Architectural Review Board

Meeting Minutes

August 13, 2018

**ARB-47-2018 Certificate of Appropriateness and Waiver
Certificate of Appropriateness for four new wall signs for CVS Pharmacy at 175 W.
Main Street (PID: 222-002559).
Applicant: DaNite Sign Co.**

Source: Main Street Elevation, Parking Lot Elevation, and Alley Elevation from Market and Main Phase 2 submittal

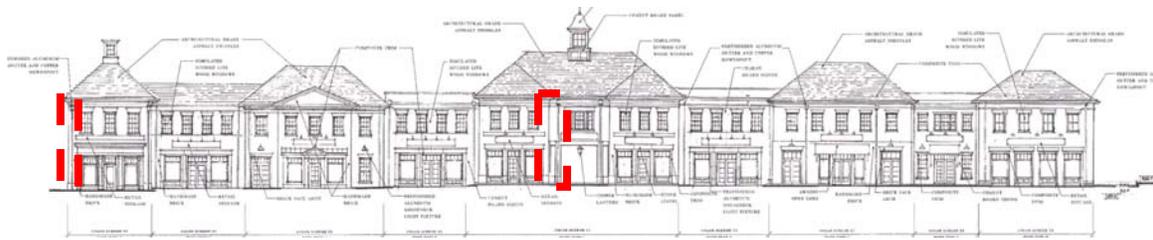
- The applicant is proposing to remove the singular door and left window currently located on the west elevation. The applicant is proposing to replace the door with a double door surrounded by windows.
- Staff recommends a condition of approval that the new double door be centered on the elevation, remove the side windows, and maintain the

- By centering the double door and removing windows on either side, the entrance will keep the symmetry of the building allow the sign to be centered over the doorway.

Staff recommends approval of this application but, should consider the proposed double door's location. The proposed signs are consistent with the other wall signs and projecting signs' designs within the Market Square area. All three signs feature cove cut corners with scalloped edges like the other signs located on this building. Both the projecting sign and wall signs are appropriate sign types for this tenant based on the circumstance that there is no access off of Main Street, and it provides directions to the access door along the parking lot elevation.

Staff recommends the double-door be centered along the west façade of the building to maintain the building's original character. The other signs throughout the area are centered, or appear centered on the façade and/or over the store entrance. By centering the double door this aesthetic is maintained and will be easier to return to the building's original design if necessary, in the future.

1. That the arm of the bracket should align with the main bracket arms of other signs within the Market Square area.
2. The new double door be centered on the elevation, remove the door’s side windows, and maintain the windows that are already installed on the building.
3. The new double door will have the same door design and hardware as the other doors on site.
